CCPS RFP#24-15 – NORTH EAST MIDDLE/HIGH SCHOOL REPLACEMENT PROJECT

ADDENDUM #01

NORTH EAST MIDDLE/HIGH SCHOOL REPLACEMENT PROJECT
CCPS RFP#24-15

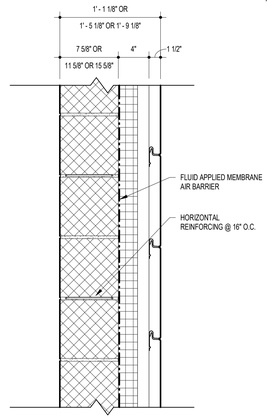
REVISE Replace wall type indicated as "NOT USED" with new Wall Type 4.1.
ADD New Wall Type 6.2.
ADD New Wall Type 6.3.

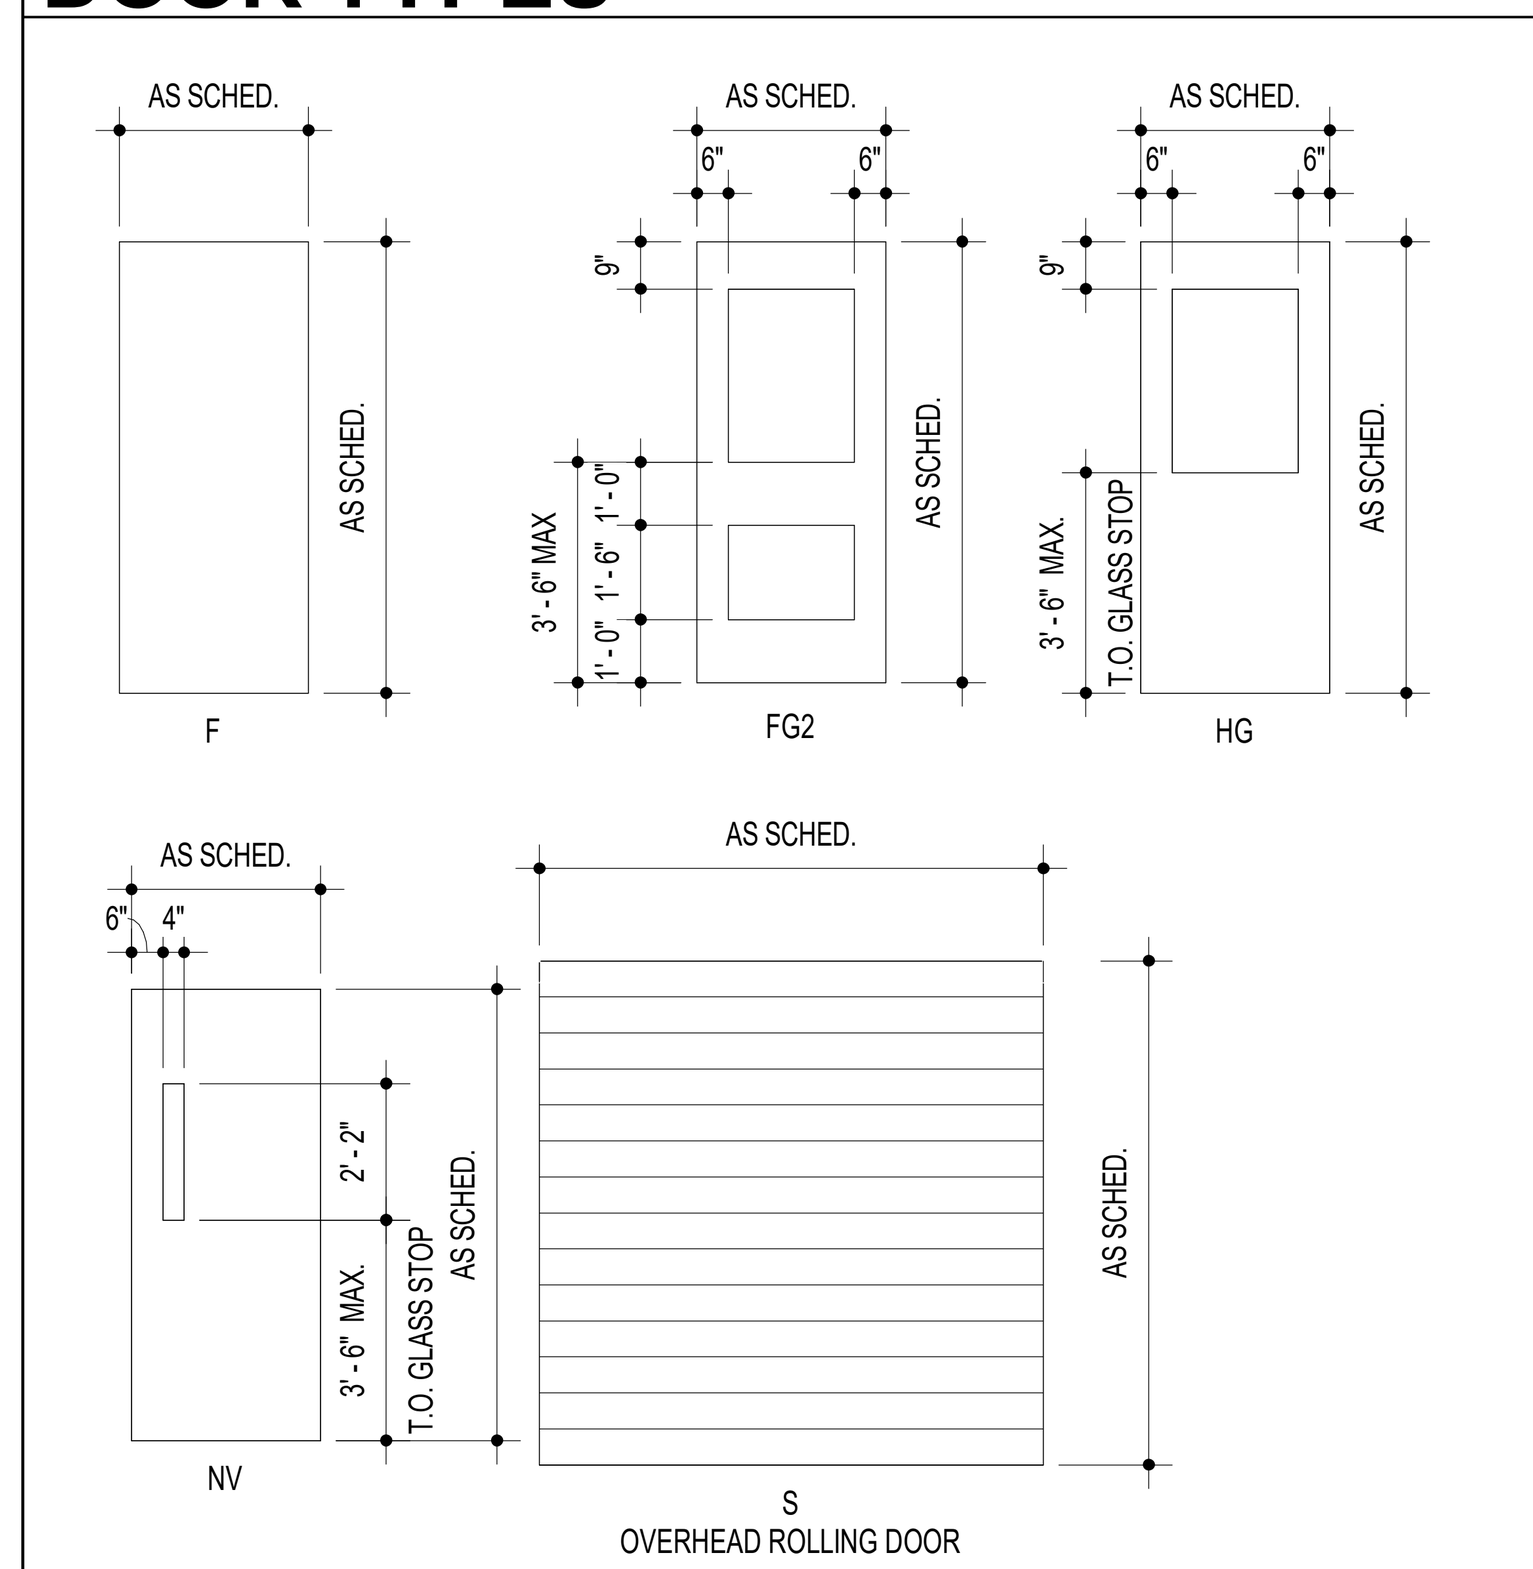
REVISE Frame Material for Doors B007A, B007B, and B007C to HM.

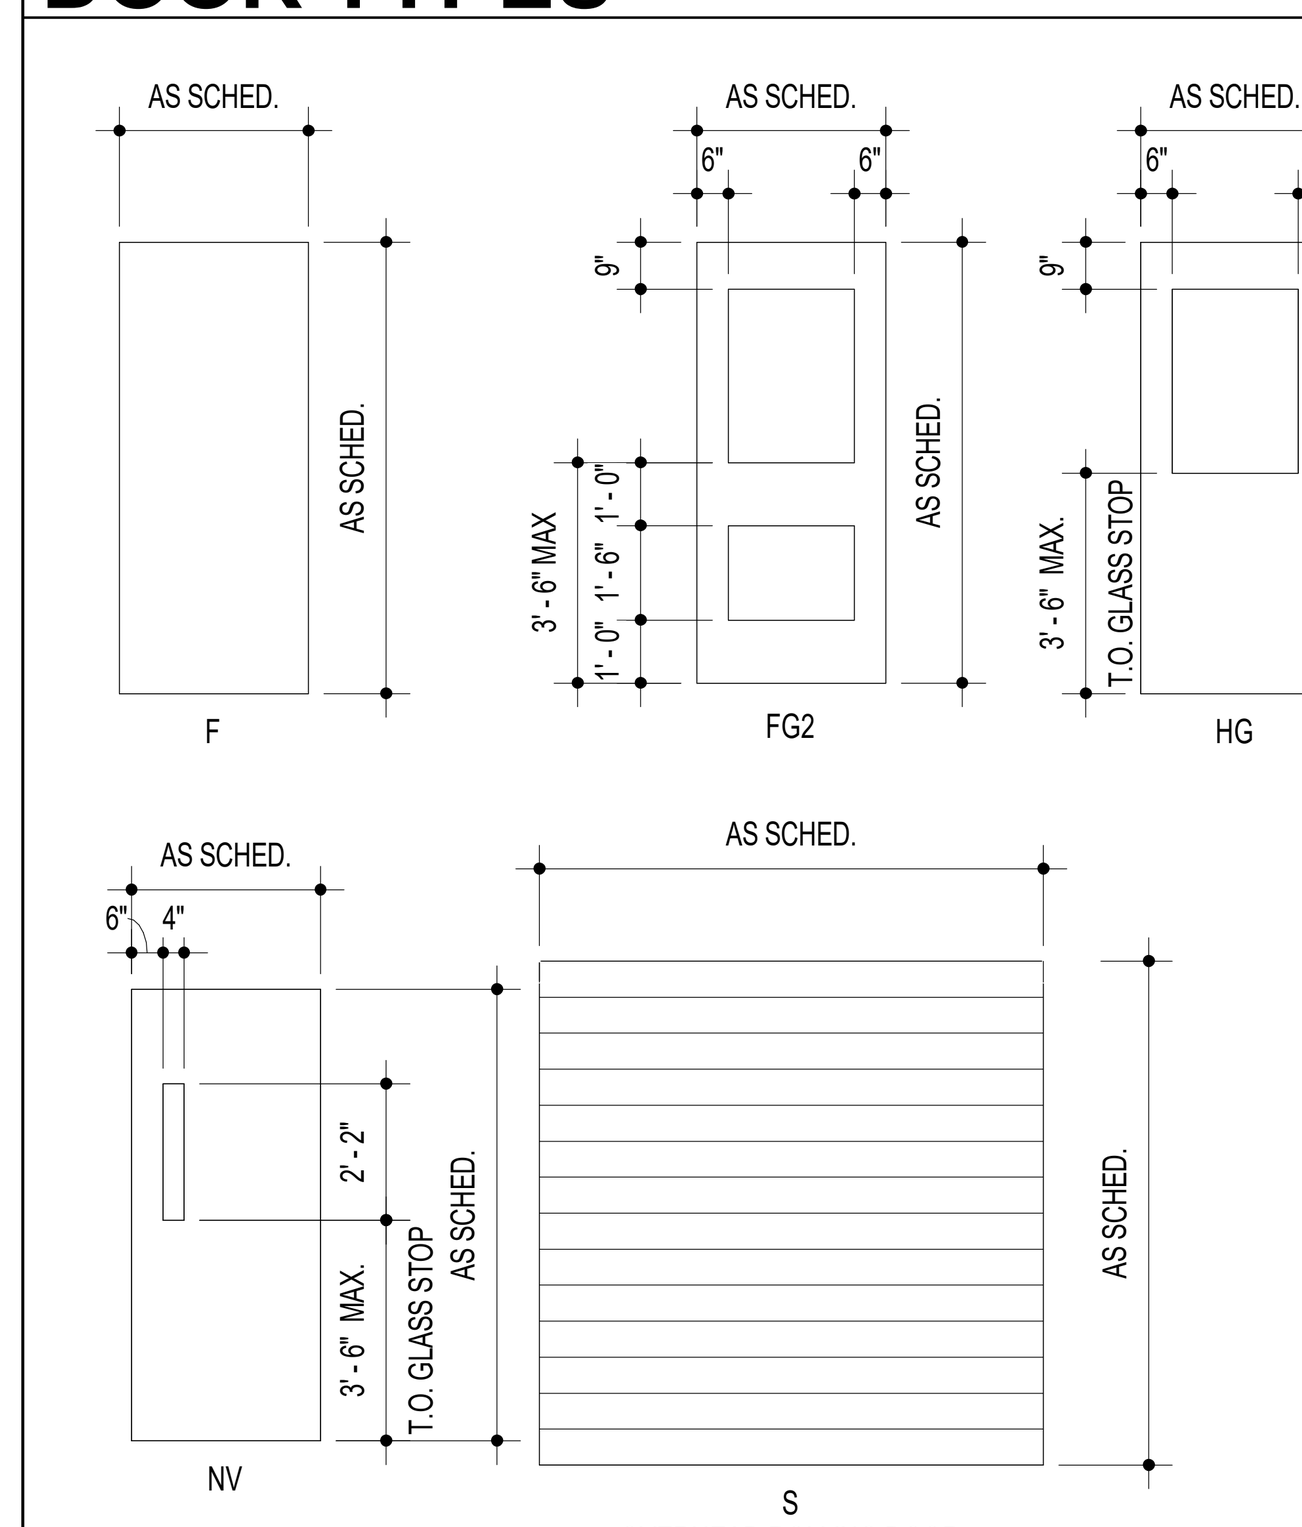
REVISE Frame Material for Doors D104A, D104B, D120A, D120B, F001A, and F001B to HM.
ADD "INCLUDE GRILLE" Remark for Door D113B.

E4 PLAN DETAIL - LVL 01 - AREA F
3/4" = 1'-0"

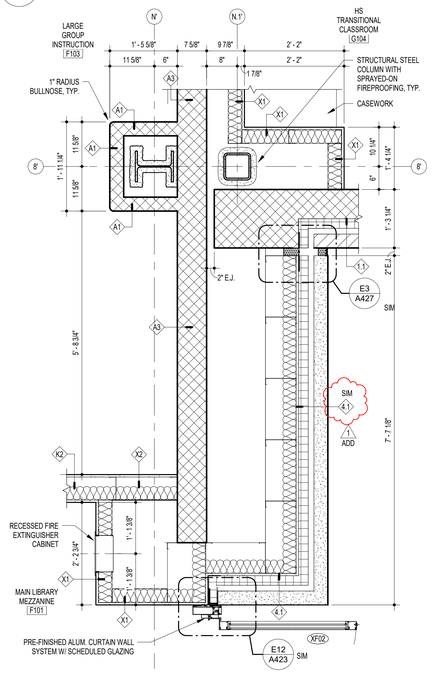
ADD 4.1 (SIM) designation in blank wall type tag on Details A4, A18, and E4.

A18 LEVEL 01 AREA D PARTIAL FURNITURE PLAN
1/8" = 1'-0"

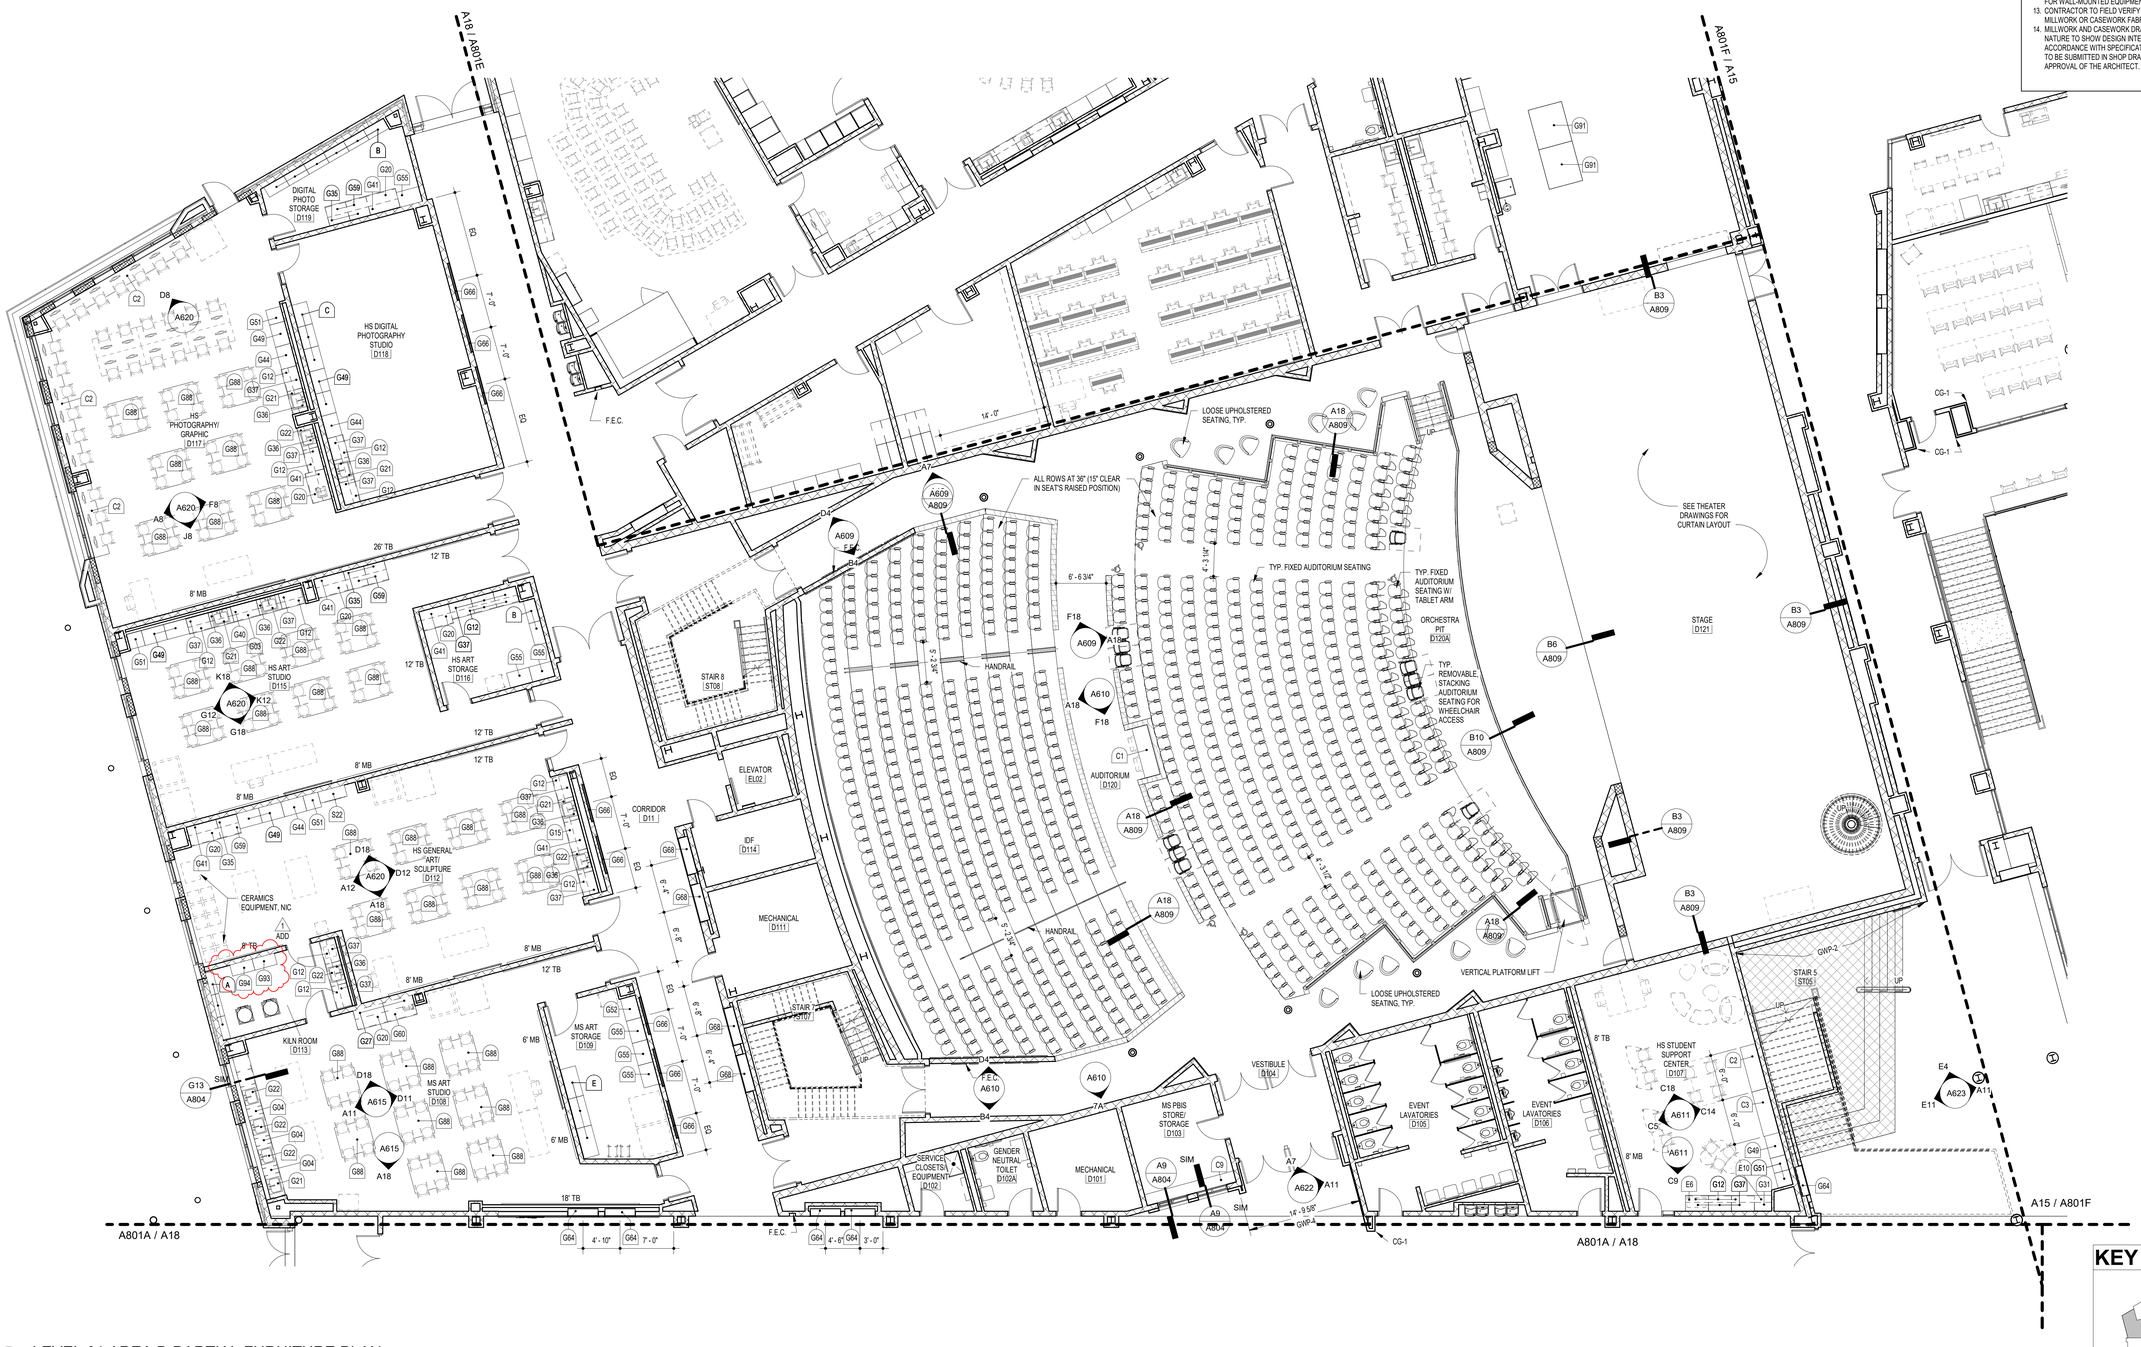
REVISE Furnishings Type G54 in KILN ROOM D113 to new Types G93 and G94.

PARTIAL 01 FLOOR PLAN - AREA D
1/8" = 1'-0"

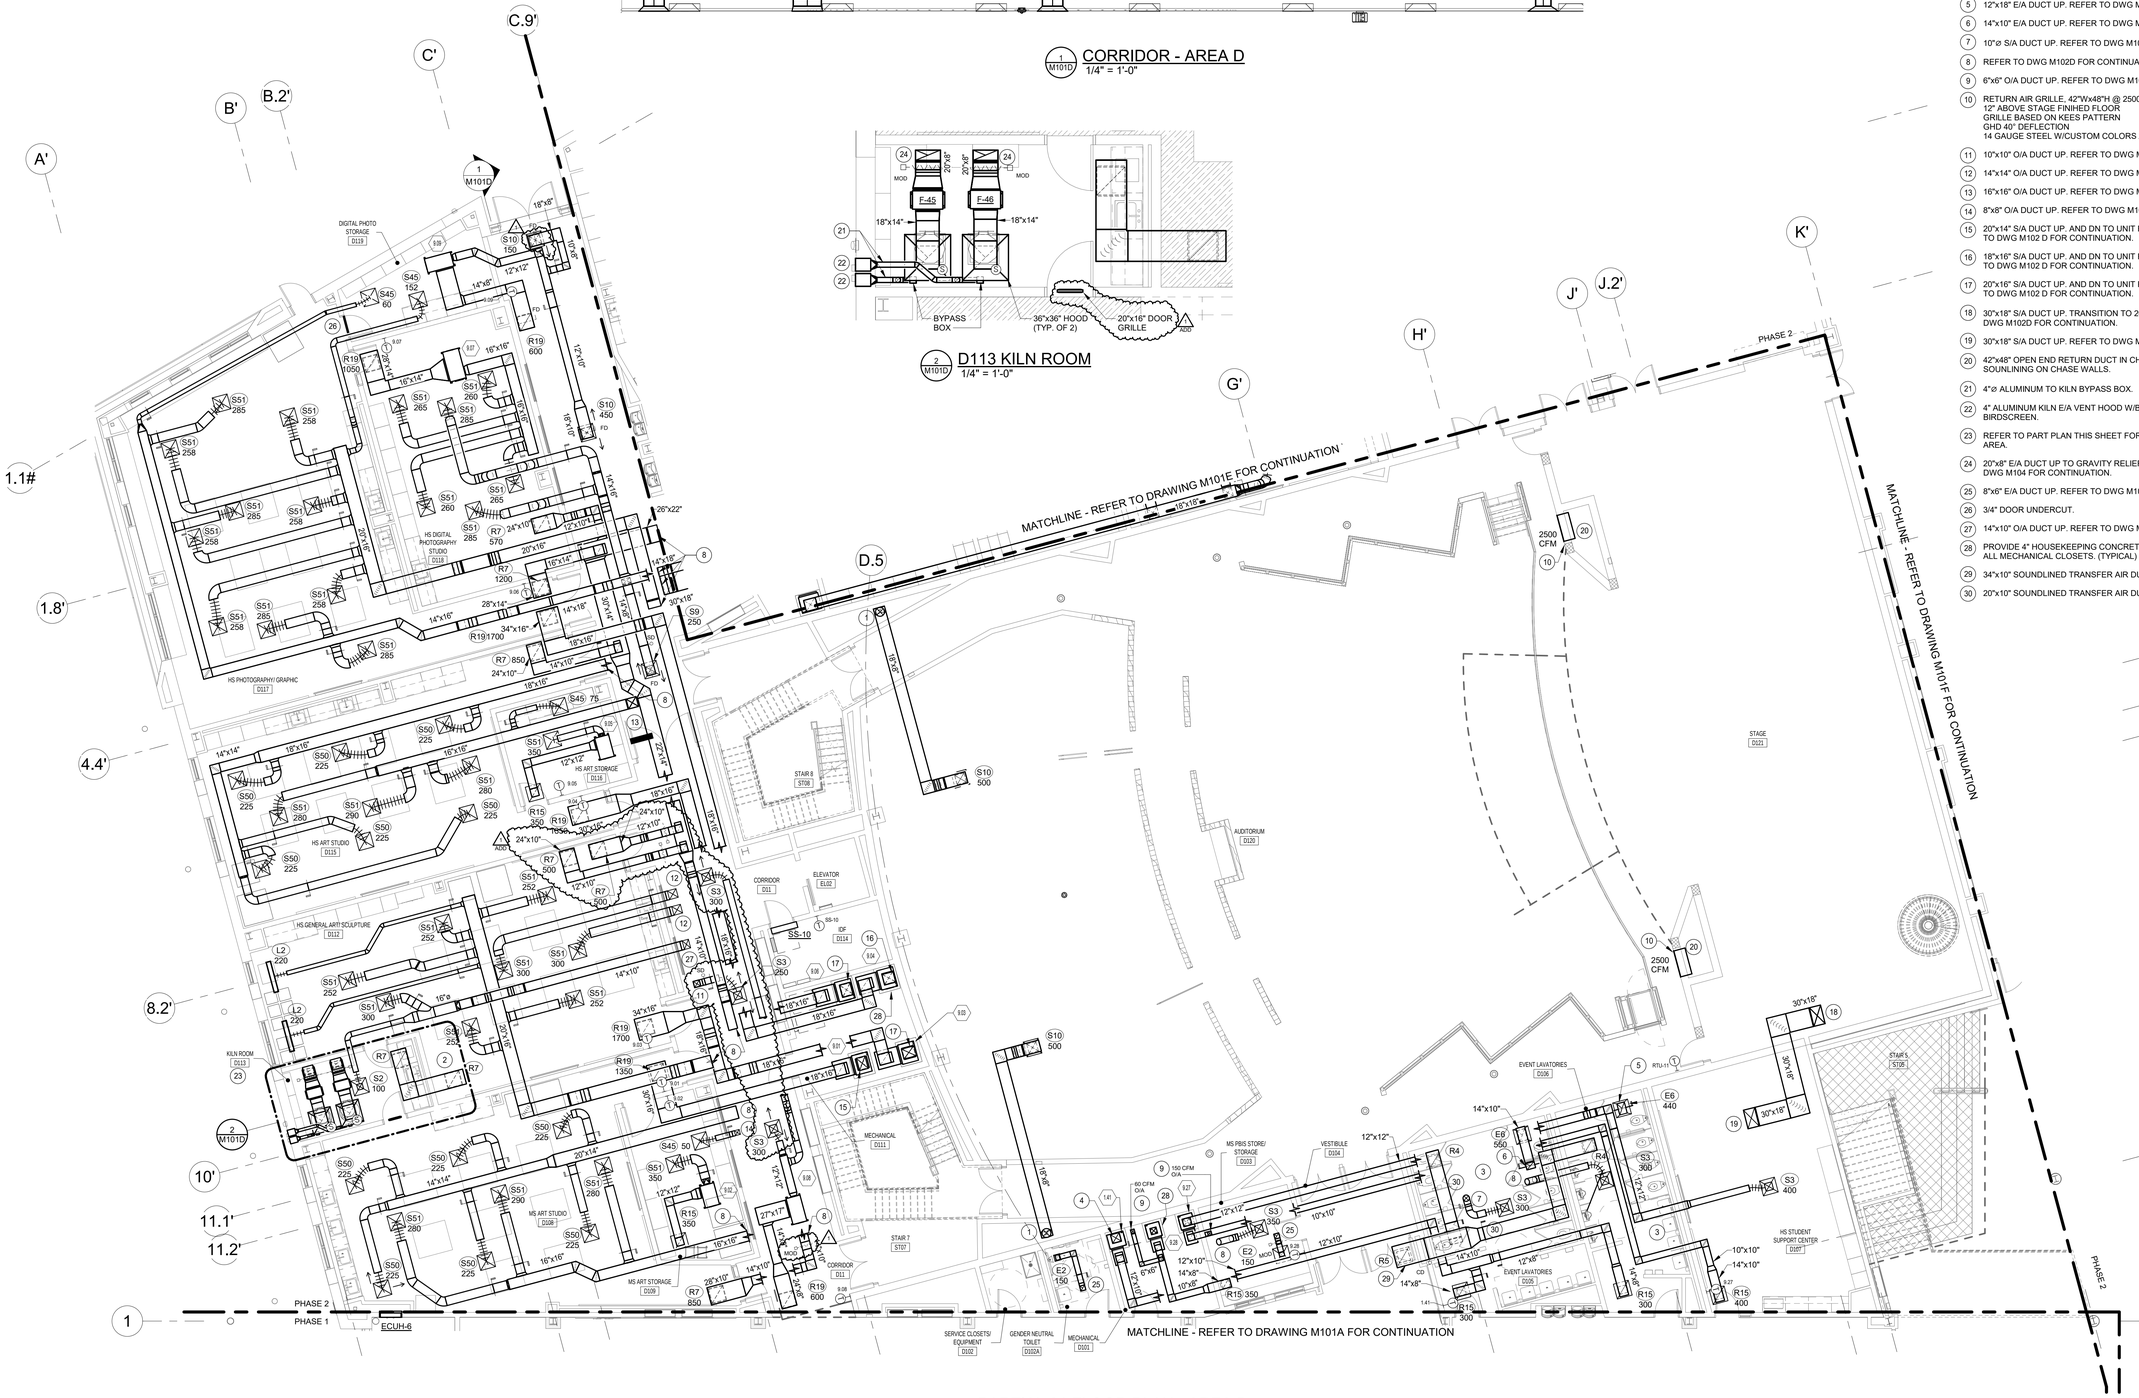
REVISE R7/1000 cfm and associated ductwork 26”x12” and 16”x12” to R7/500 cfm and associated ductwork to 24”x10” and 12”x10” with MOD in HS/GENERAL ART/SCULPTURE D112.

ADD R7/500 cfm and associated ductwork of 24”x10” and 12”X10” with MOD in HS/GENERAL ART/SCULPTURE D112.

REVISE S3/300 CFM supply diffuser, S3/250 CFM outdoor diffuser including all associated duct work, air flow direction and drawing note bubble arrowhead in Corridor D11.

ADD MOD to 14”X10” R/A duct in Corridor D11.

ADD 20”x16” door grille to Kiln room D113.
